HURON A PROJECT AREA LAKEVIEW AVENUE

COMMENTS INCLUDED IN THIS FIGURE ARE FROM SURVEY RESPONSES AND COMMUNITY MEETING INPUT THROUGH 03.01.11

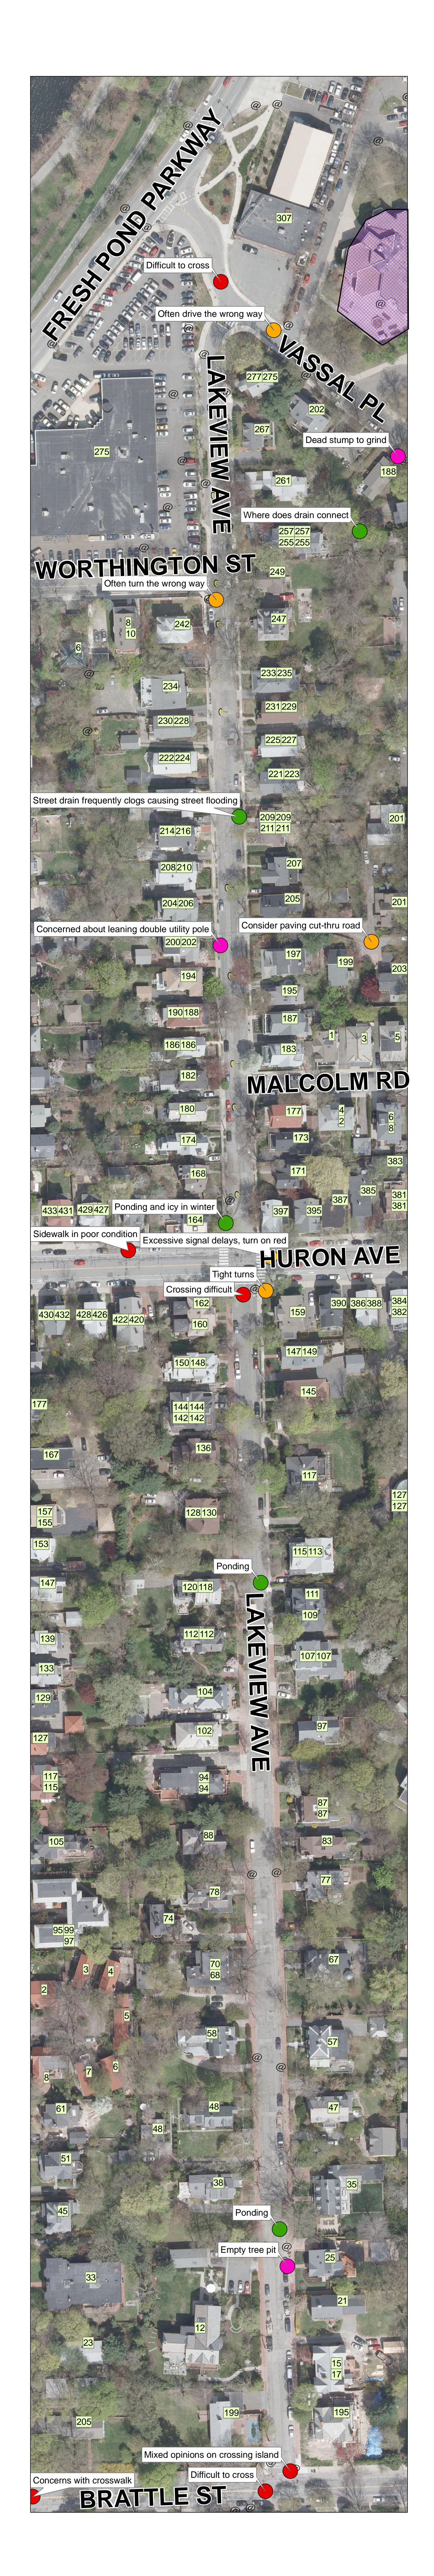
COUPLE OF PROPERTIES HAVE STREET RUNOFF DRAIN TOWARDS BACKYARD.

A COUPLE OF PROPERTIES WITH SEWER SERVICE ISSUES.

BOTH ENDS OF LAKEVIEW AVENUE HAVE UNEVEN SIDEWALKS. DRIVING ISSUES

SPEED IS A MAJOR CONCERN. POTHOLES ARE EVERYWHERE.

DRIVERS OFTEN DRIVE THE WRONG WAY ON SECTION BETWEEN HURON AVENUE AND FRESH POND PARKWAY.

SECTION OF STREET BETWEEN BRATTLE STREET AND HURON AVENUE IS TOO WIDE OPEN, WHICH ENCOURAGES SPEEDING.

CONCERNED WITH LOSS OF ON-STREET PARKING BETWEEN VASSAL LANE AND JUST SOUTH OF HURON AVE. WOULD BE WILLING TO TRADE SOME ON-STREET PARKING SAPCES IN REMAINING SECTION FOR OTHER IMPROVEMENTS - TREES, TRAFFIC CALMING, ETC.

DIFFICULT RIDE ON LAKEVIEW AVENUE BETWEEN HURON AVENUE AND FRESH POND PARKWAY. THERE ARE TOO MANY POTHOLES.

ONE-WAY STREETS MAKE CYCLING INEFFICIENT. CONSIDER TWO WAY CYCLING AND DESIGNATED BIKE LANES.

CONSIDER PLANTINGS AND TREES. NEW GREENSPACES WOULD HAVE TO BE MAINTAINED BY NEIGHBORHOOD. #83, 87, AND 107 LAKEVIEW AVE ARE INTERESTED IN GARDENING.

CONSIDER OVERHEAD WIRE CALMING AND RELOCATE UNDERGROUND.

RAISED MEDIANS/ISLANDS ARE NOT PREFERRED.
